March 1, 2024

Project No. 111390

RE: Response to the Preliminary Adequacy Review - Western Equipment & Truck Mine #1, 112c Construction Materials Reclamation Permit Application, File No. M-2023-043

To:	Craig Sparrow	From:	Jason Andrews, P.E. Eric Roads, E.I.T.
Company:	Western Equipment and Truck, Inc.	Date:	February 12, 2024
EA No.:	111390		
Re:	Exhibit C – Pre-Mining and Mining F Affected Lands V2 Applicant: Western Equipment and Truc Address: 23988 U.S. 34, Kersey, CO

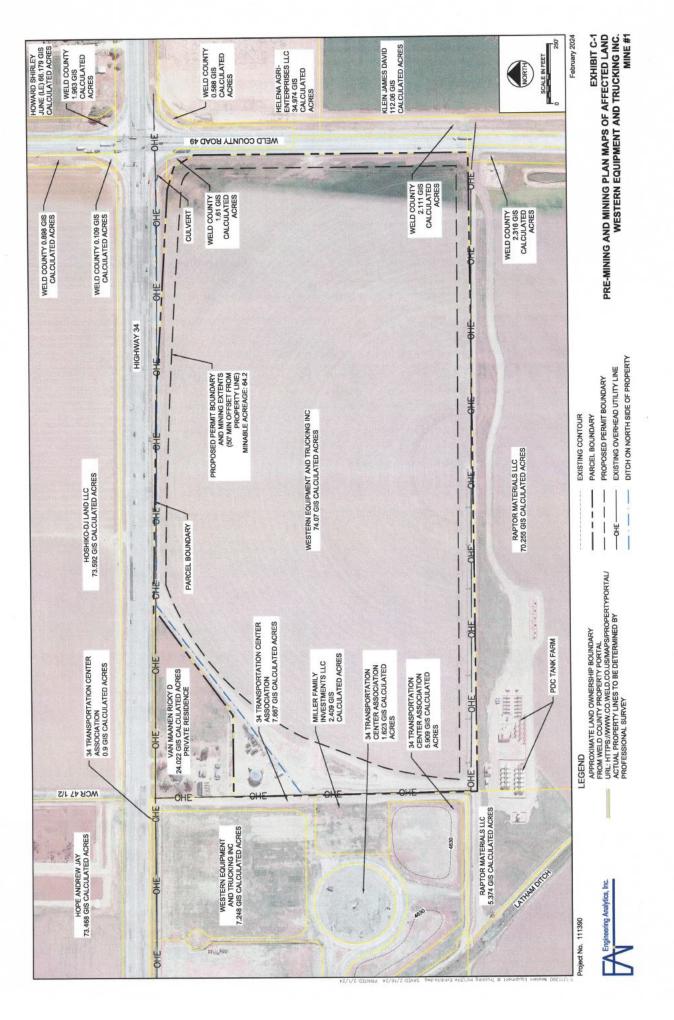
Comment 3 – Please add features to maps C-1 and F and to their legends which delineate between the proposed permit boundary, parcel area outline, and the area of minable acreage.

Comment 5- Please add a label and line to all site maps to outline where any transmission or utility lines as referenced in Exhibit C are located. Please also outline and label the location of the southern oil and gas facility on all maps. Ensure that a proper legend accompanies these features.

Comment 7- Pursuant to Rule 6.4.3(g), please update the label for the parcel owned by Van Maanen to state what type of structure is located in the parcel. Ensure that any additional structures outlined on the map through this adequacy review also indicate the type of structure present.

Response: Figures C-1 and have been updated to include a boundary line between the proposed permit boundary, parcel, parcel area outline and the area of minable acreage.

Response: The transmission/utility lines have been added to all site maps, and the legends have been modified to include the transmission/utility lines. The oil and gas

facility, located near the southwest corner of the subject parcel, has been added to all maps, and the legends have been modified to reflect this addition.

Response: Exhibit C-1 has been modified to reflect that the Van Maanen property is a private residence.

To:	Craig Sparrow	From:	Jason Andrews, P.E. Eric Roads, E.I.T.
Company:	Western Equipment and Truck, Inc.	March 1, 2024	
EA No.:	111390		
Re:	Exhibit F – Reclamation Plan Map V2 Applicant: Western Equipment and Truc Address: 23988 U.S. 34, Kersey, CO	k, Inc.

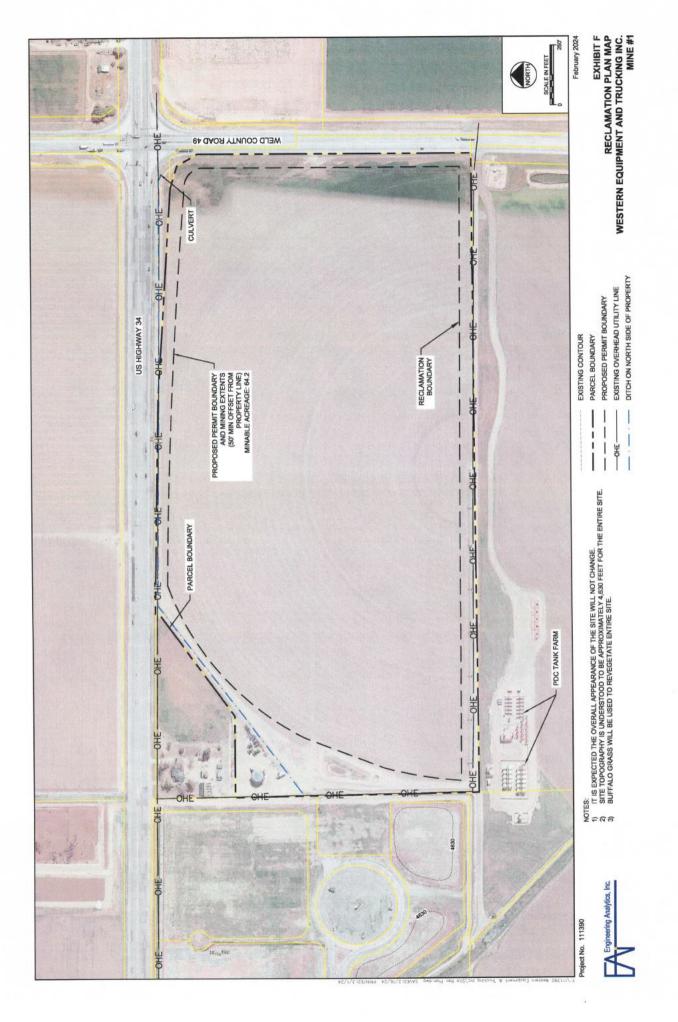
Comment 8 - The proposed mining plan states that the area to be mined has $\sim 24-26$ inches of topsoil available and that mining activity would strip $\sim 10-12$ inches of topsoil. Using conservative estimates, this would leave ~ 12 inches of topsoil still on the mined area. If this is the case, please clarify for the Division why the proposed plan only commits to leaving a minimum of 2 inches of topsoil over the gravely sand subsoil. Please also update Exhibit E to include this clarification

Response: The proposed minable depth was set at 10-12 inches to meet our client's requirements for mining profitability. The estimated topsoil does state 24-26 inches of minable topsoil. The proposed mining depth has been revised to be 10 to 20 inches with . We updated our commitment to leave at minimum 6 inches of topsoil to meet all regulations and promote the best seed growth. Without mining the area, it is difficult to know the exact minable area and depth of topsoil. Exhibits E, F and D has been modified to clarify the depth of the topsoil to be mined.
